BARRICK MERCUR GOLD MINE

SUBJECT: 3809 (U-027)
U27-86-09P (89-1A)
Request for Modification of Decision

TO: G. M. Eurick
FROM: R. D. Collard
SUBJECT: Proposed Changes to the Sunrise Dump

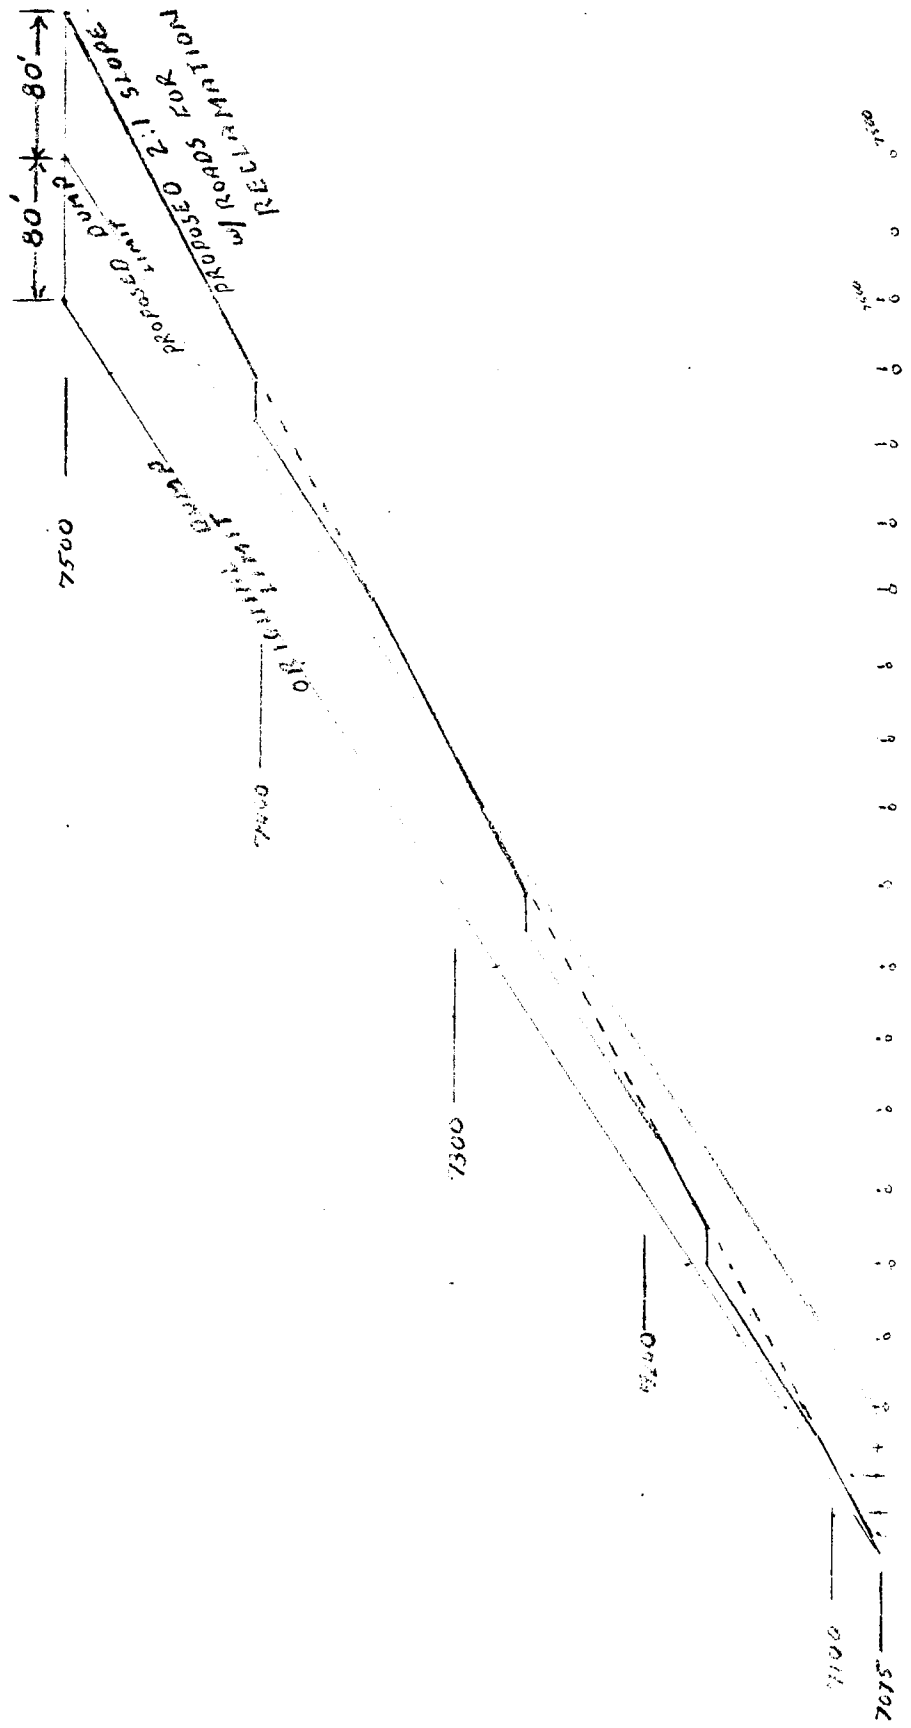
It is my recommendation that the requirements for building the Sunrise Dump to specifications stated by the BLM need to be revised for safety and excessive land disturbance reasons.

First, in order to achieve the 100-foot benches every 80 vertical feet, one must construct the dump from the bottom up. To build in this manner, it would require 3,450 feet of 10 percent grade haulage road with three switchbacks. It would be a down-hill loaded situation with no area for a run out or runaway ramp. This practice is totally unsafe, and an alternate plan is mandatory.

In addition to the safety factor, it would require excessive land disturbance to construct such a road for safe haulage to the 7155 elevation.

1. Reduce the capacity of the dump by moving the crest line back approximately 80 feet.
2. Upon completion of the dump, shape the down-hill portion to a 2:1 slope.
3. Construct reclamation access roads as required to a maximum width of +20 feet. This would allow ample room for a hydroseeding machine on the dump face.
4. Spread available topsoil for reclamation of the dump.

The proposed plan would involve approximately 600,000 tons of material and four weeks dozer time to attain the 2:1 slope.
